LAKE NONA TOWN CENTER PHASE 2A

LAKE NONA TOWN CENTER PHASE 2

SUMMARY

EXHIBIT H: OPEN SPACE MAP

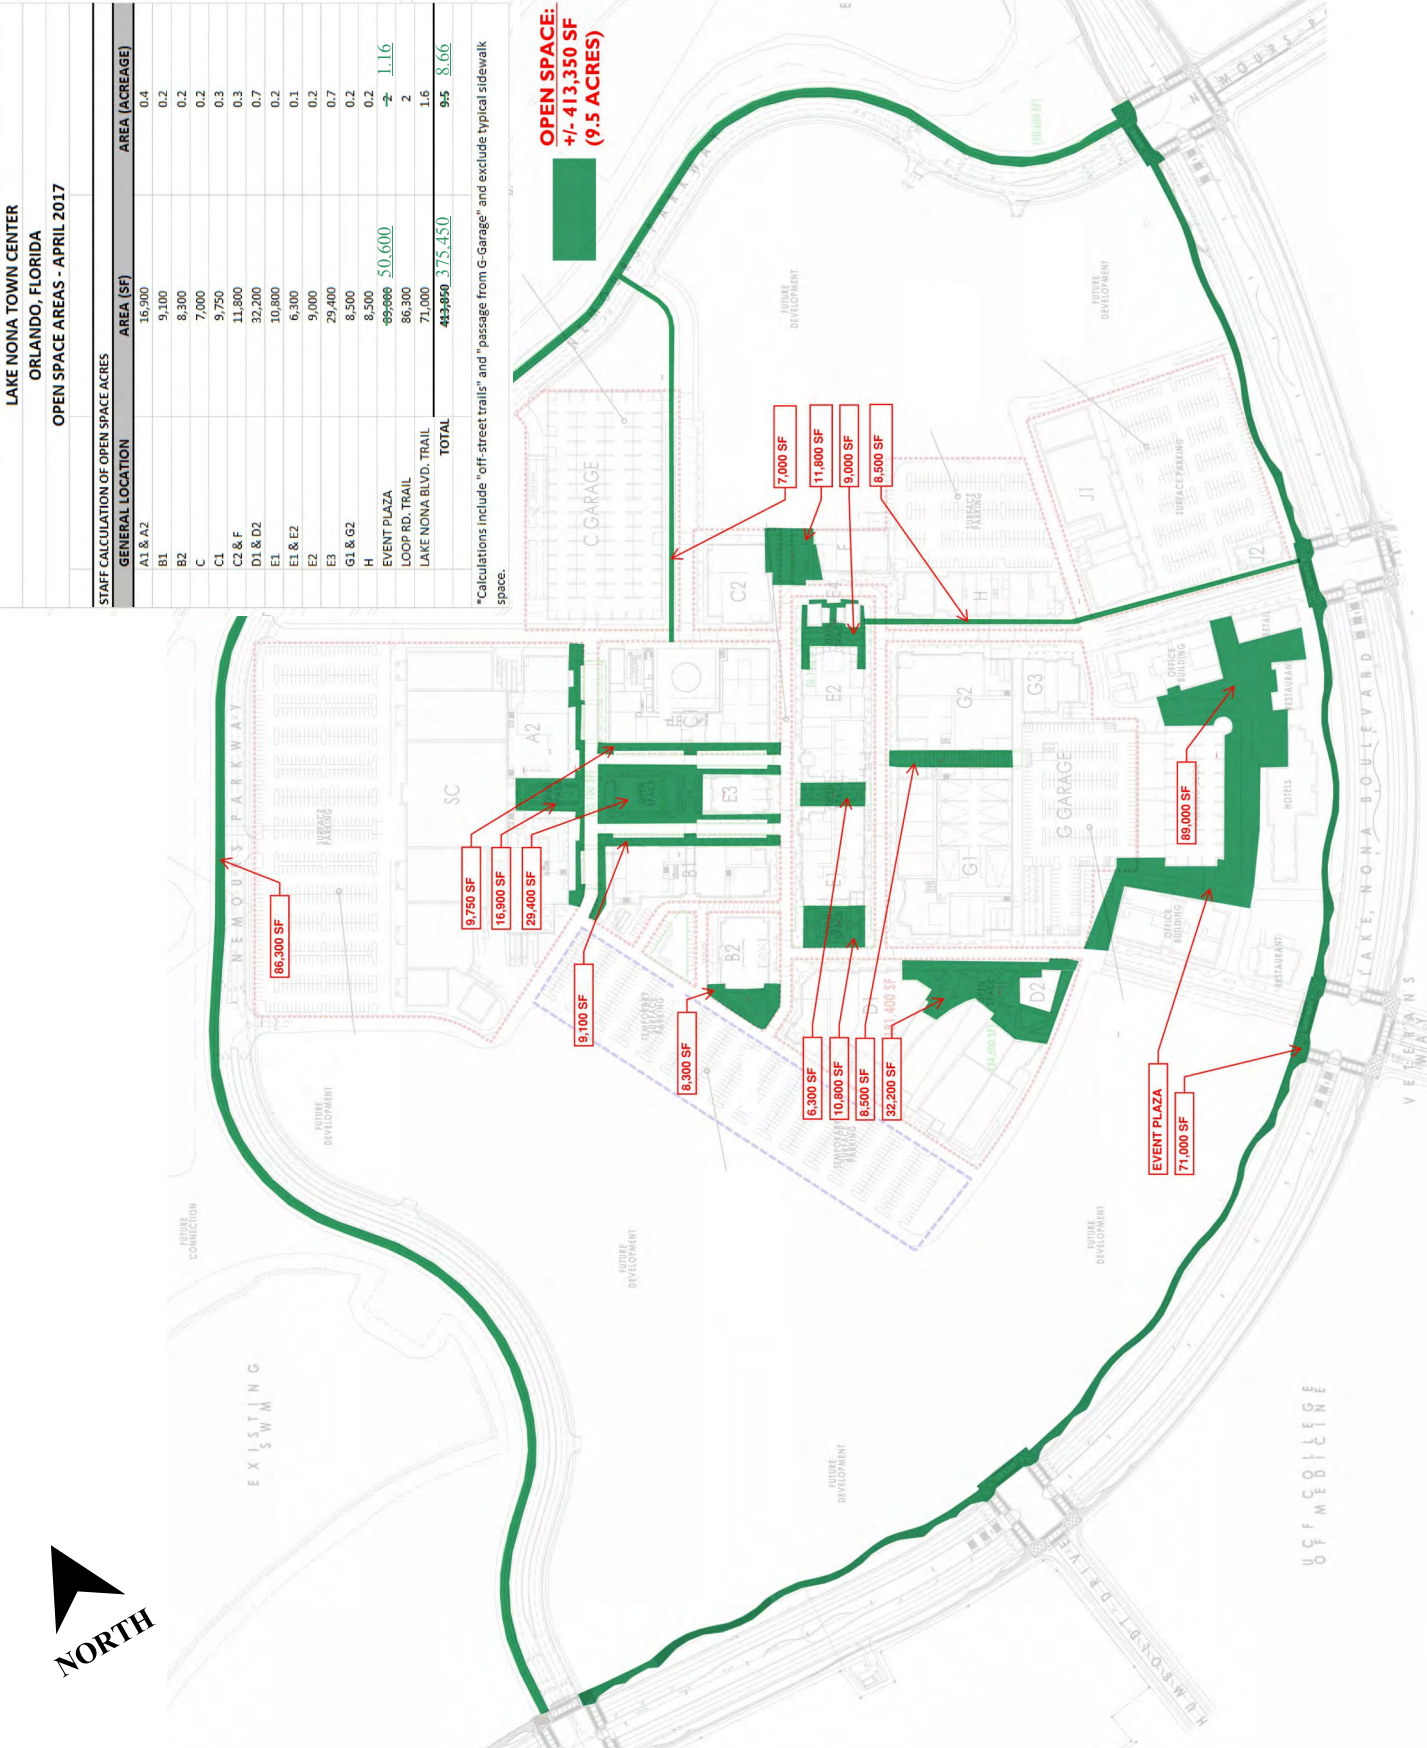
In the original writing of this report, as presented to the SETDRC, the proposed development program did not achieve the minimum 10% civic/greenspace requirements. On April 19, 2017, the developer provided revised open space calculations for Phase 1 and Phase 2A that include the existing multi-use trail along Lake Nona Blvd. The calculations also include areas not typically considered civic/open space, such as sidewalks and streets, however the applicant has indicated that these areas will be programmed with robust and consistent civic events. **Page 10** reflects updated open space calculations and **Page 22** shows the exhibit submitted by the developer on April 19.
